**PLANNED UNIT DEVELOPMENT &
SUBDIVISION STAFF REPORT****Date: March 5, 2015**

SUBDIVISION NAME Longleaf Gates Subdivision, Phase One (Revised Plat) Resubdivision of Lots 26 & 27

CONTEMPLATED USE Planned Unit Development Approval to amend a previously approved Planned Unit Development to allow a private street, gated subdivision, with reduced lot sizes, reduced front and side yard setbacks, and increased site coverage; and a Subdivision to relocate the existing interior lot line between two legal lots of record.

SITE PLAN

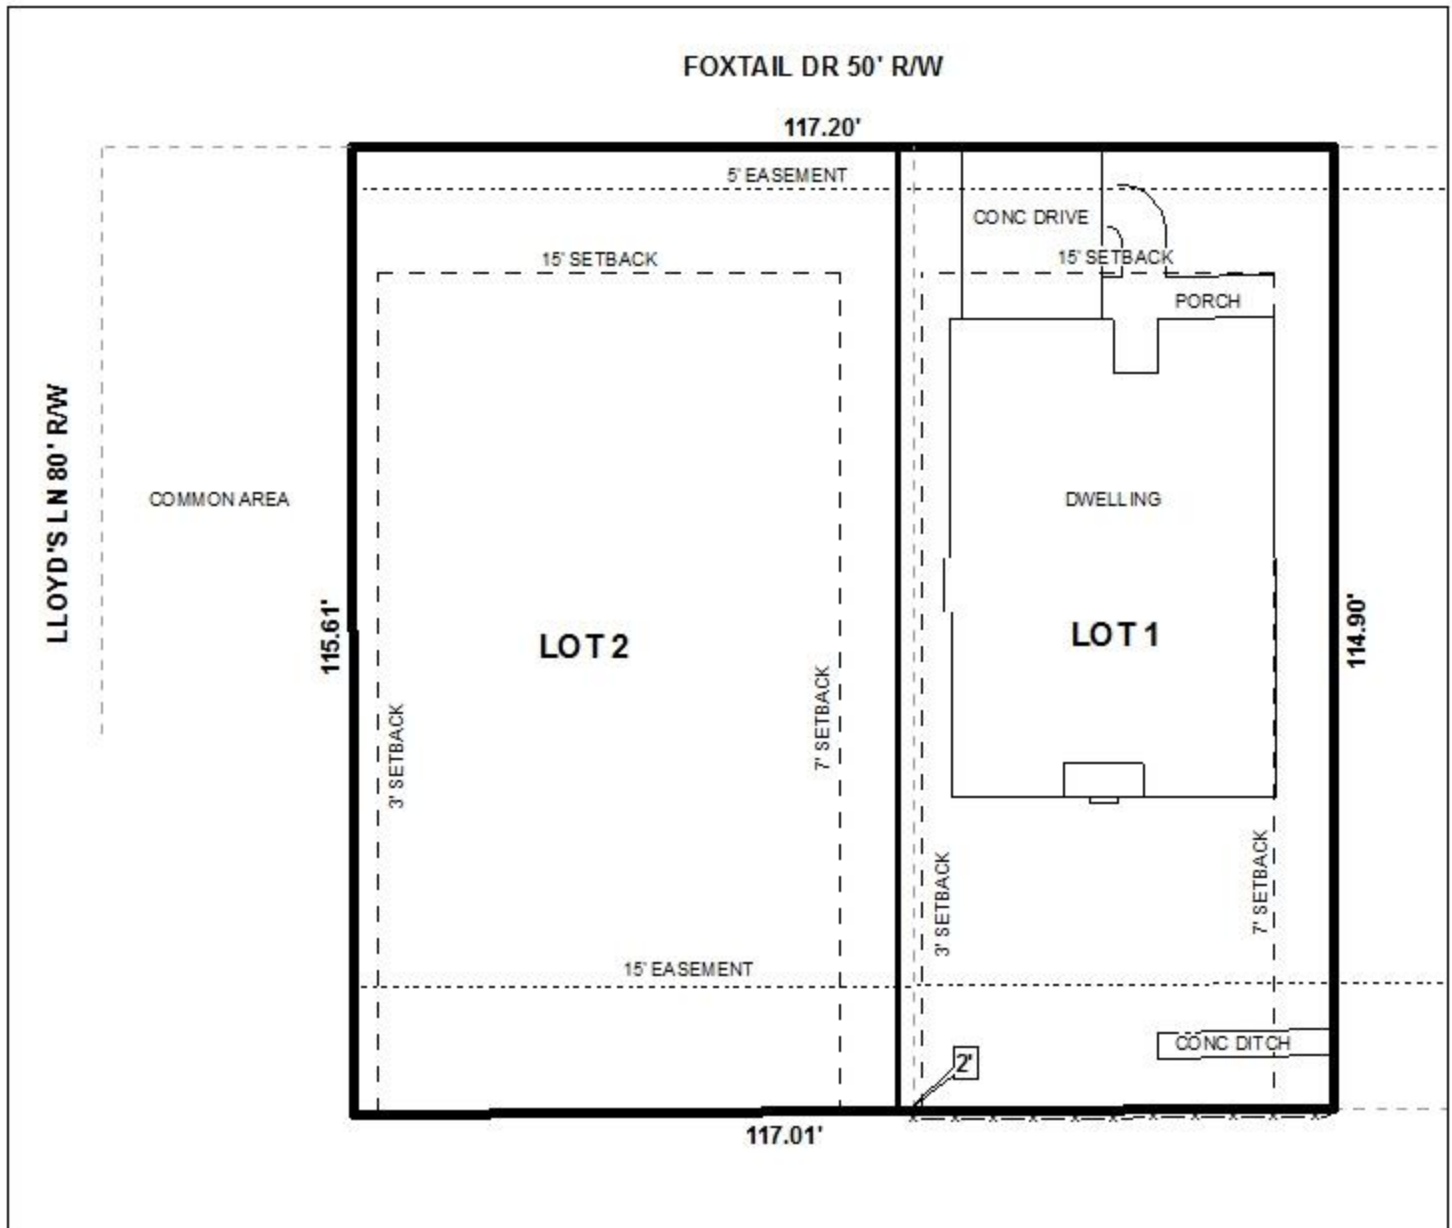
lot sizes, reduced front and side yard setbacks, and increased site coverage. The applicant wishes to relocate an interior lot line between two legal lots of record to accommodate an error made during construction of a dwelling on Lot 26. The submitted site plan illustrates the AC unit for Lot 26 located over the current property line, which will require either the property line or the AC unit to be relocated.

When the dwelling was initially permitted, the AC unit was illustrated on the East side of the dwelling; however, it was actually constructed on the West side, which resulted in the encroachment into the adjacent lot.

The proposed subdivision fronts Foxtail Drive, a minor street with curb and gutter. The preliminary plat illustrate an existing right-of-way of 50', therefore no dedications will be required. As a means of access management, a note should be placed on the site plan and Final Plat stating that each lot is limited to one curb cut each to Foxtail Drive.

There is a 15' drainage and utility easement on the South property lines, as well as a 5' Alabama Power & AT&T easement along the North property lines. A note should be placed on the site plan, as well as the Final Plat if approved, that no structures will be erected in the easements.

- 1) retention of the 15' front yard minimum building setback, and 3'/7' side yard setbacks as on the preliminary plat;
- 2) retention of the lots sizes in square feet and acres;

- 3) placement of a note stating that the lots are limited to one curb cut each to Foxtail Drive;
- 4) placement of a note stating that no structures shall be erected in any easements;
